Comments on a Substantive Application under section 53 of the Fast-track Approvals Act 2024: Hydrology

Fast-track project name	Mt Welcome, Pukerua Bay, Porirua
Fast-track application number	FTAA-2603-1181
GW file number	FTA260348

Technical area	Hydrology (including Wetland Hydrology)
Date	6 July 2026
Author	James Blyth
Statement of expertise	I am a Director and Water Scientist at Collaborations Limited ('Collaborations'). I hold a Master of Science (MSc) Degree with first class honours from the University of Waikato, with a thesis completed on wetland eco-hydrology. I am also a Certified Environmental Practitioner (CEnvP) under the Environmental Institute of Australia and New Zealand (EIANZ). I have ~16 years of work experience, and have worked internationally in over six countries. This experience covers a range of water sciences, including water quality, water resources, hydrology, hydraulics and wetlands. I have provided evidence for hearings, Environment Court and High Court processes.
Code of conduct	I confirm that I have read and agree to comply with the Code of Conduct for Expert Witnesses contained in the Environment Court Practice Note 2023. This technical memorandum has

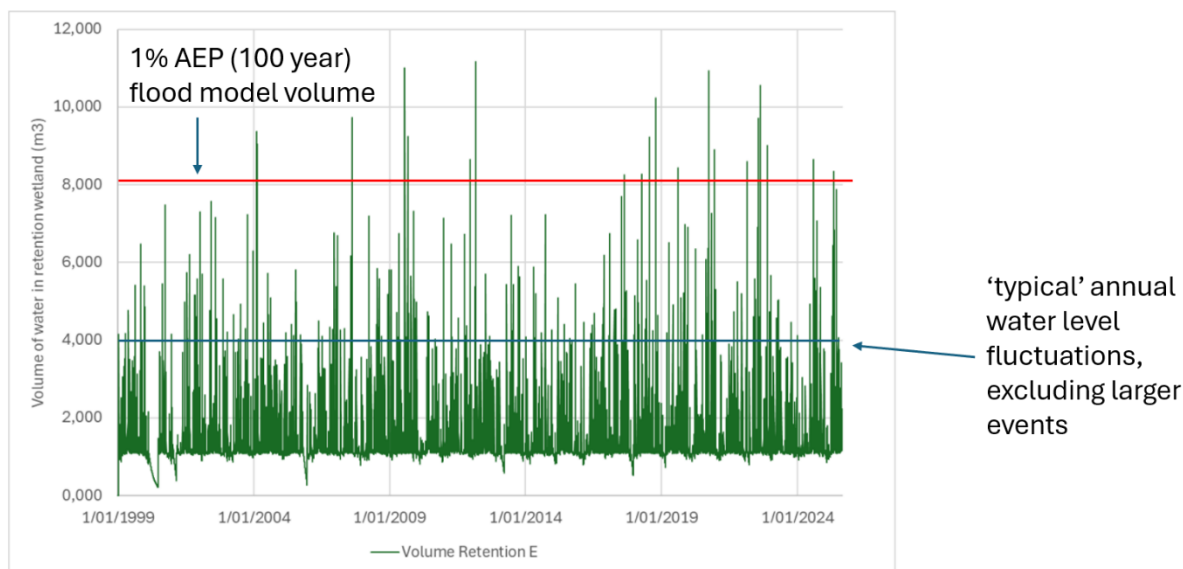
11. Some of this uncertainty in the model outputs may be evident in Figure 33 of the hydrology report, reproduced in Figure 1 below. This chart shows over 20 storm events in a 25-year simulation led to wetland storages exceeding 8,000 m³, and five events exceeding 10,000 m³.

12. The wetland design drawings (Appendix 30-26) state the 1% Annual Exceedance Probability (AEP) design storm for retention wetland E resulted in a stored volume of 8,150 m³. The numerous events in the GoldSim model (at nearly an annual frequency) that reach similar volumes to the 1% AEP, 12 hour design storm may be due to the utilisation of daily (24 hour) rainfall totals, however, it does appear to indicate the long term hydrological model (for this catchment at least) may overestimate the runoff out of the post development catchments.

Figure 2. Water depth assessment for retention Wetland A to estimate the approximate depth and area of permanent standing water. This adapts figures from the wetland design drawings (Appendix 30-26).

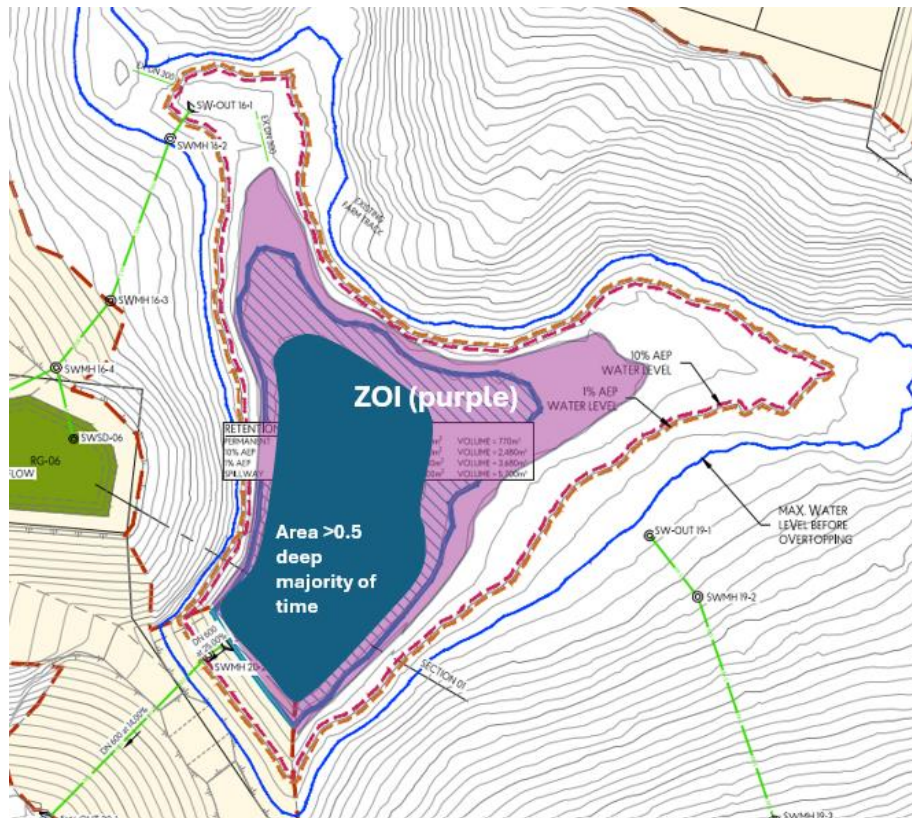
29. This assessment is useful to identify a zone of influence (ZOI) where standing water levels will fluctuate throughout the year, typically between 0.5m to 1m deep, a depth I consider would be possible, but challenging to establish and maintain permanent cover of aquatic plants (such as *Eleocharis* and *Machaerina*) to achieve appropriate ecological conditions and offsetting requirements. An example of this is provided below for Retention Wetland A, utilising the 0.5m contours and wetland design drawings (Figure 2).

30. This assessment found that for retention wetlands A, B and C, ~20-30% of the area considered for ecological offsetting (the 10 year, or 10% AEP extent) would have permanent water depths exceeding 0.5m (under low flow/baseflow conditions), indicated by the dark blue extent in Figure 2. This area would be challenging to establish permanent aquatic plants and may remain as open water.
